**TO:** HEARINGS OFFICER

**SUBJECT:** **CONDITIONAL USE / CLASS 3 SITE PLAN REVIEW CASE NO. CU-SPR23-02**  
**3997 CARSON DRIVE SE – 97317**  
**AMANDA NO. 23-102368-PLN**

Summary: New oil-change facility and residential units in the CR (Retail Commercial) zone.

**1 DEVELOPMENT SITE PLAN**  
0' 5' 10' 20' 40' 60'  
1" = 20'-0"

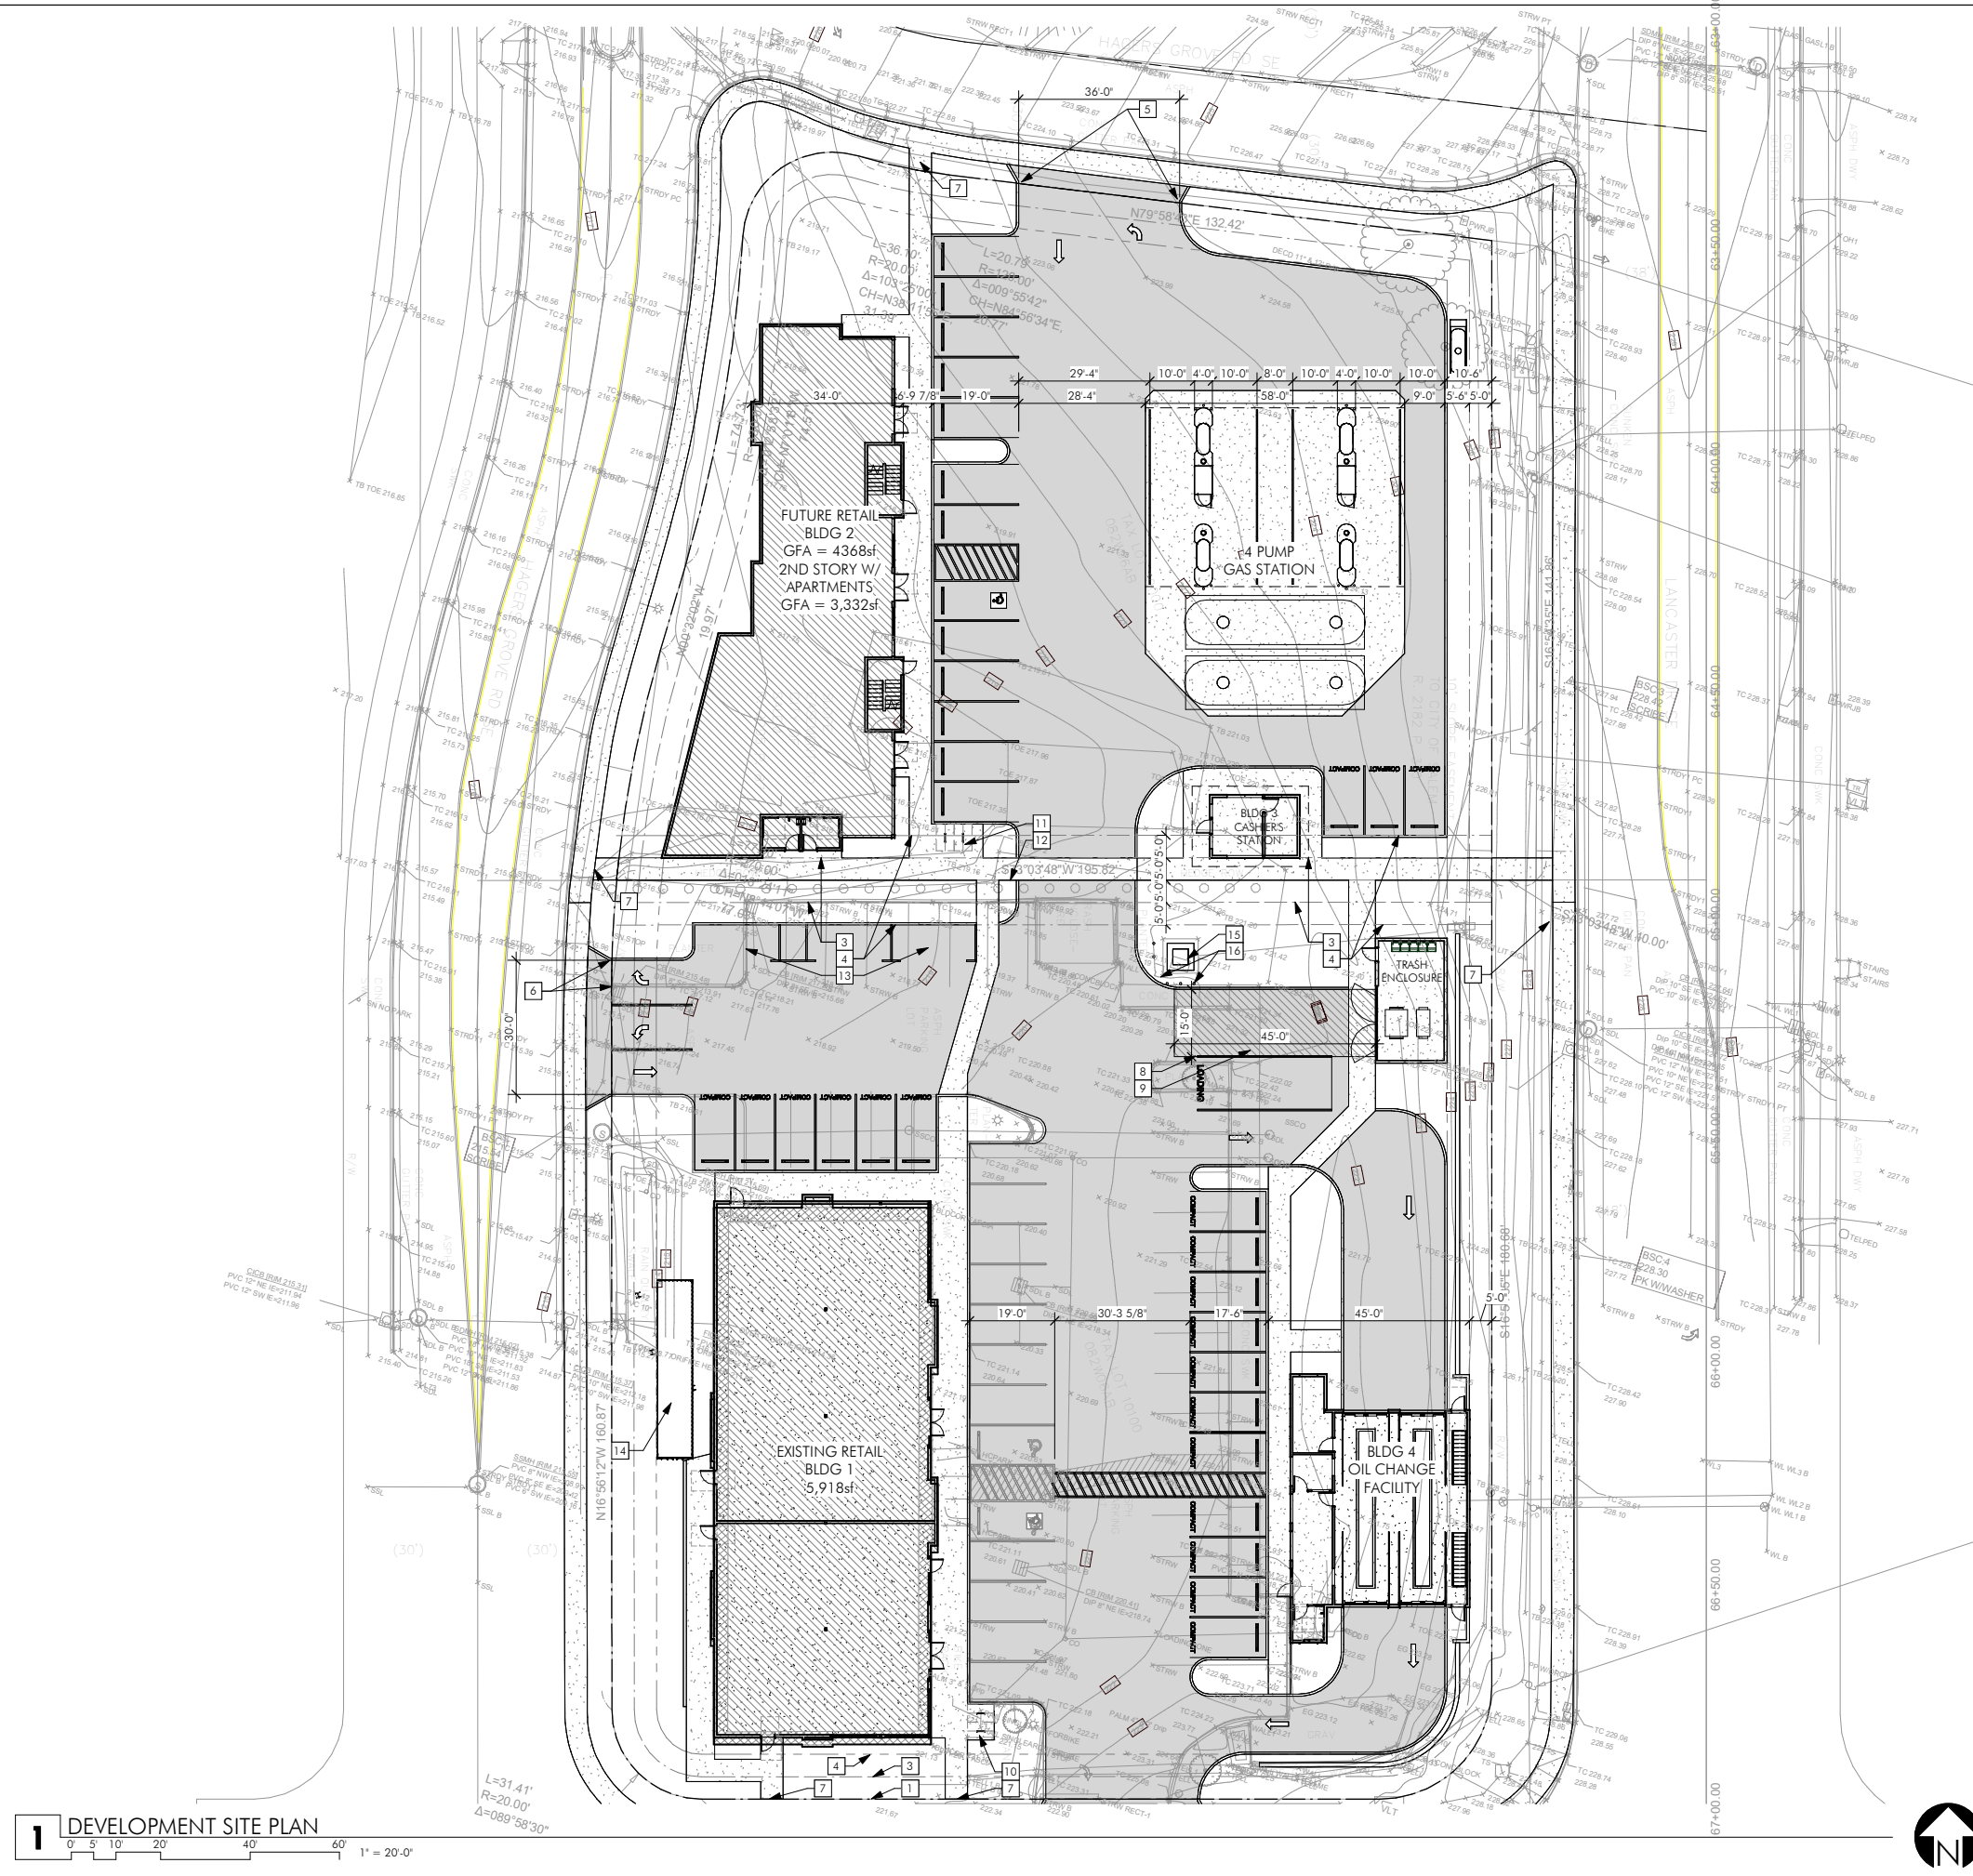
The proposed site plan indicates that 48 parking spaces will be provided on site, 20 of which are compact spaces; therefore, the proposal meets the standards.

**Finding:** The applicant's site plan indicates four proposed bike parking spaces on the east side of the north building and four existing bike parking spaces on the east side of the south building, both of which are within a convenient distance of their respective building entrances. The applicant has provided details that indicate the bicycle racks meet the required dimensions and design standards. Further conformance will be verified at the time of building permit review.

**Finding:** The site plan indicates 14,889 square feet (21.96 percent) of landscaped area is proposed for the development site, meeting the minimum landscaping requirements in the CR zone. At the time of building permit review, the applicant will provide a full landscape plan demonstrating how the development site meets Type A landscaping, including all new and existing landscaped areas.

There is an existing slope easement on the subject property that was acquired by the City of Salem for the realignment of Hagers Grove Road SE. The applicant's site plan shows one of the new buildings located within the easement area. New structures are not permitted within City of Salem easements. Prior to issuance of a building permit for the new structure, all, or a portion of, the easement shall be quitclaimed.

**Condition 2:** At the time of building permit review, the applicant shall provide either six large shrubs or six ornamental trees (equivalent of 12 plant units) within the landscape strip along the 44-foot-long length of the oil-change facility abutting Lancaster Drive SE.
